Wisconsin Department of Transportation

Proposal #5: 1320-23-70
STH 11, ERF to Wisconn Valley Way
EFR to Wisconn Valley Way
STH 11
Racine County

Letting of July 9, 2019

This is Addendum No. 01, which provides for the following:

Addendum No. 01
ID 1320-23-70/73
Added Sheet 24A
July 1, 2019

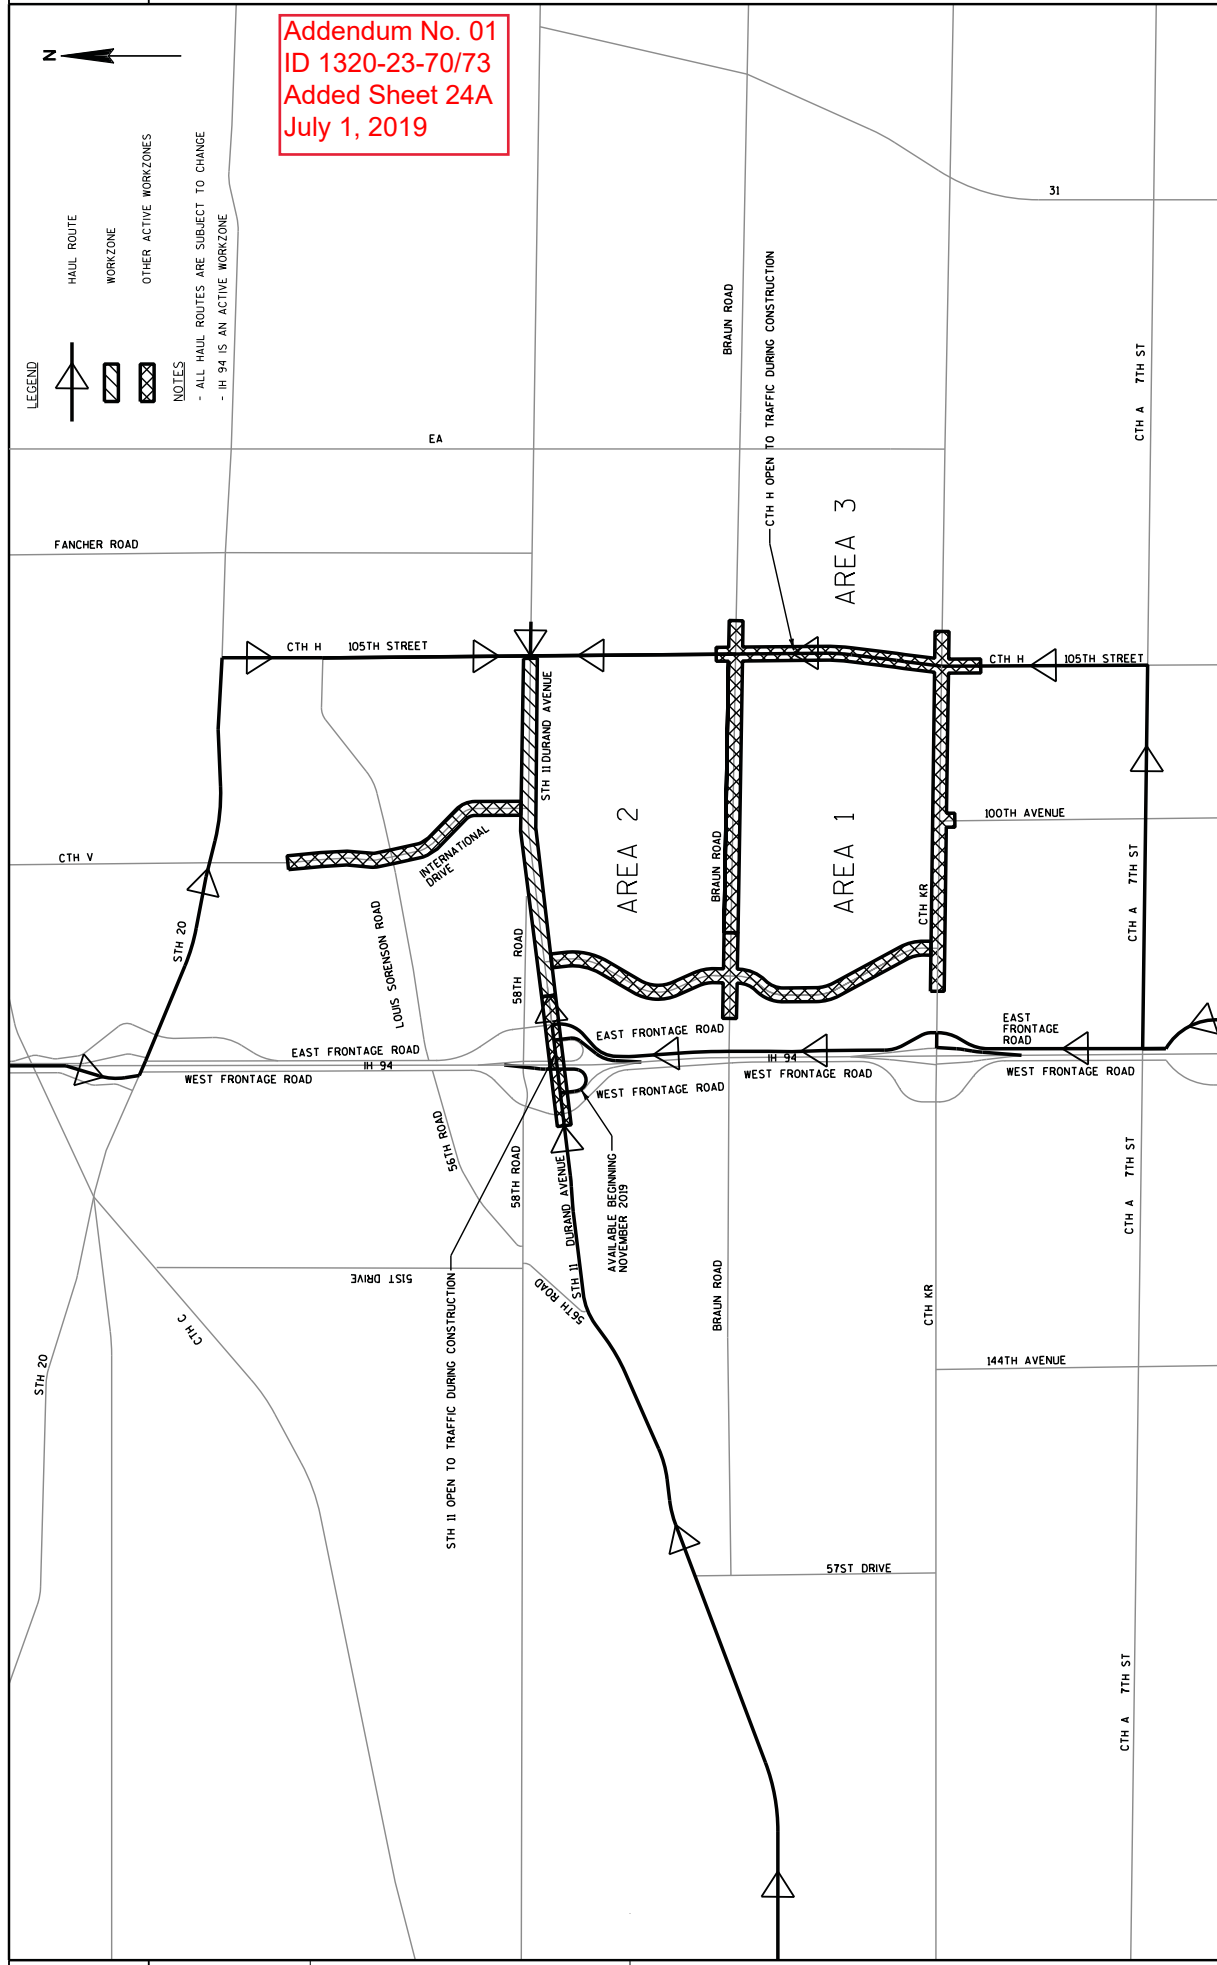
Added Plan Sheets	
Plan Sheet	Plan Sheet Title (brief description of why sheet was added)
24A	Construction Details:2019 Haul Routes (added haul route map for 2019)
24B	Construction Details:2020 Haul Routes (added haul route map for 2020)

Addendum No. 01
ID 1320-23-70
Revised Sheet 112
July 1, 2019

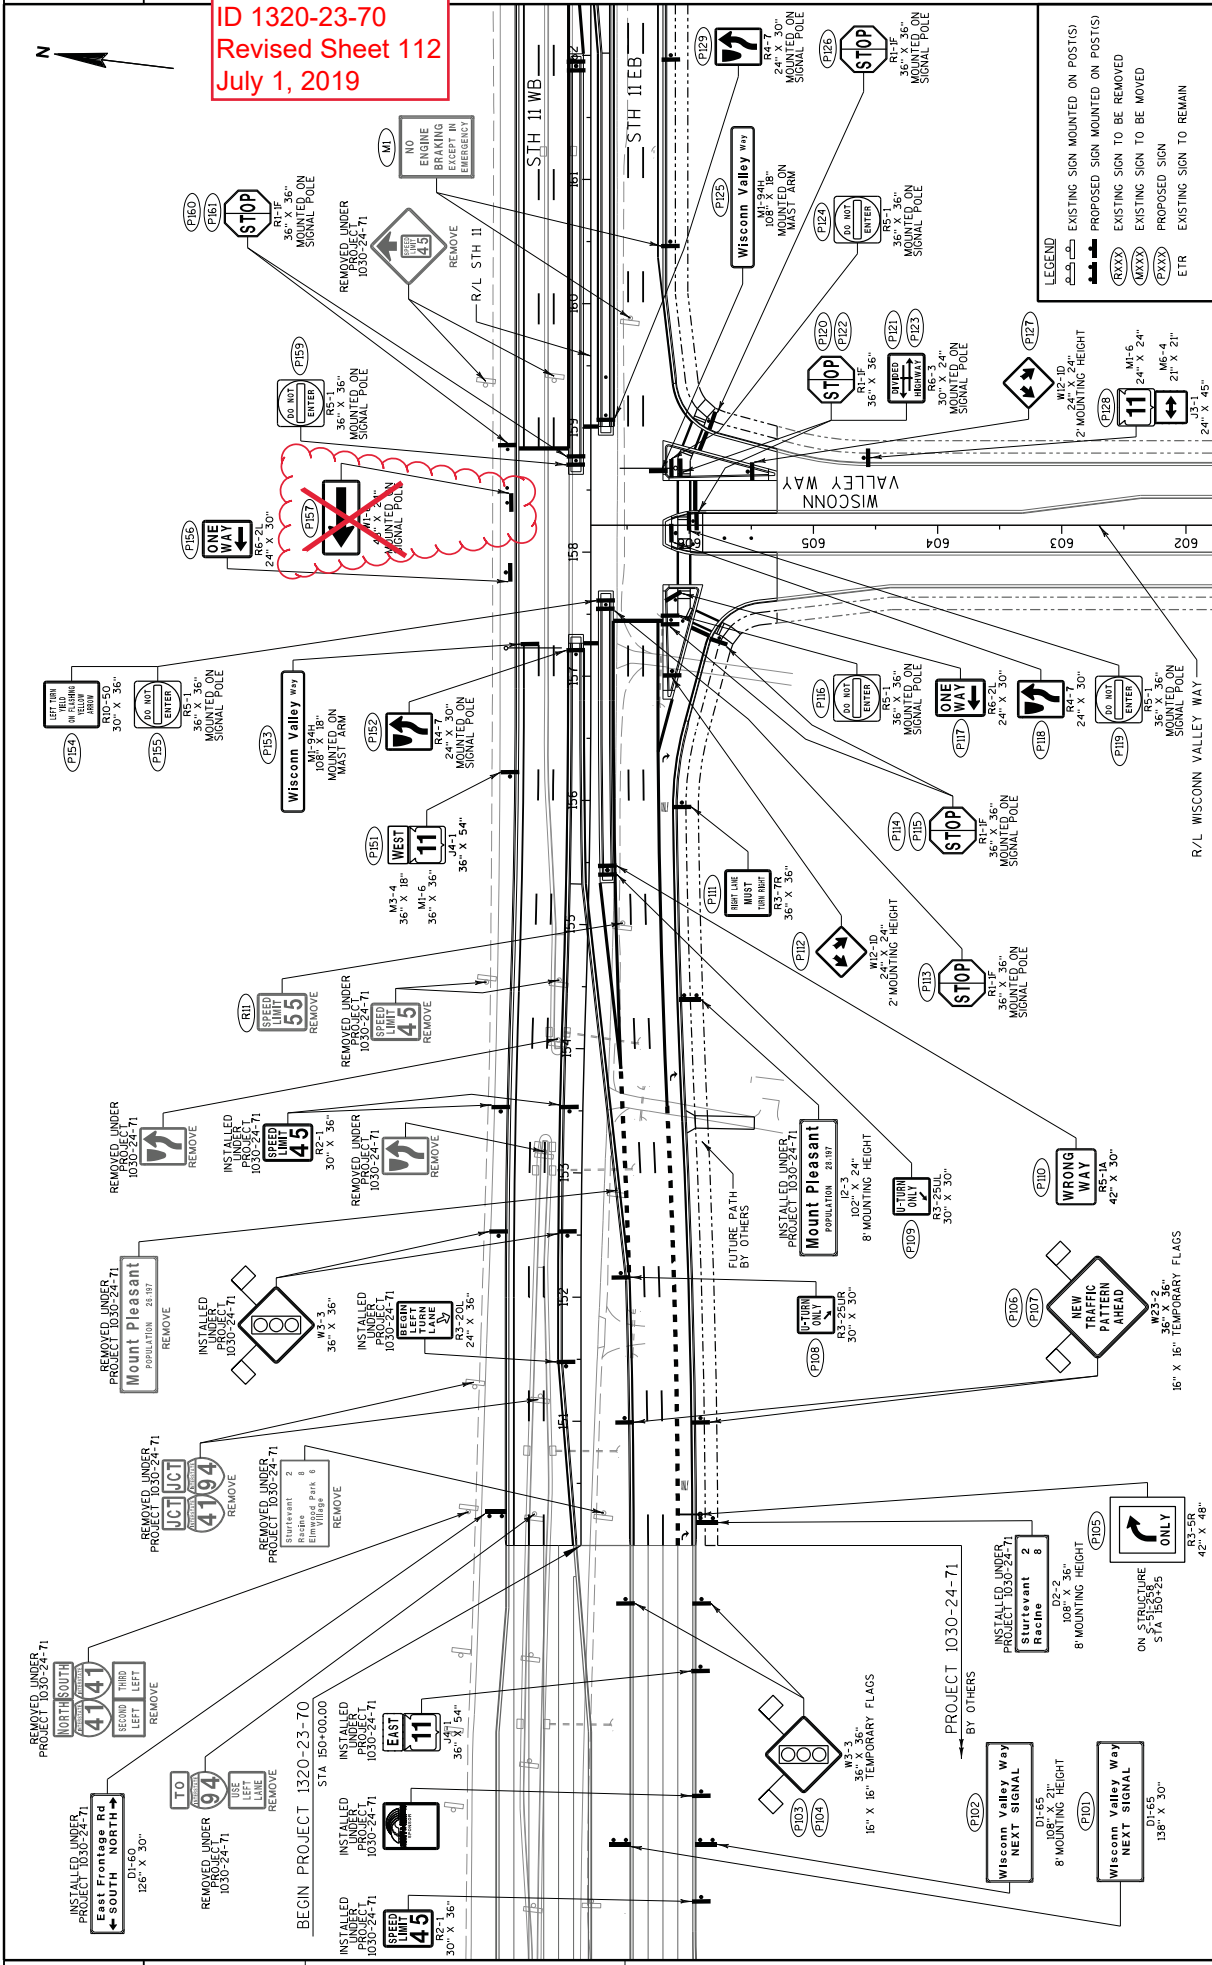
Revised Plan Sheets	
Plan Sheet	Plan Sheet Title (brief description of changes to sheet)
112	Signing Plan (removed sign P157)
116	Signing Plan (removed sign P407)
231	Miscellaneous Quantities (updated 'Earthwork' table)
248	Miscellaneous Quantities (updated 'Permanent Signing' table)
251	Miscellaneous Quantities (added 'Geogrid Type SR' table)
272	Miscellaneous Quantities (updated 'Earthwork' table)
295	Miscellaneous Quantities (updated 'Permanent Signing' table)
297	Miscellaneous Quantities (updated 'Permanent Signing' table)
301	Miscellaneous Quantities (added 'Geogrid Type SR' table)
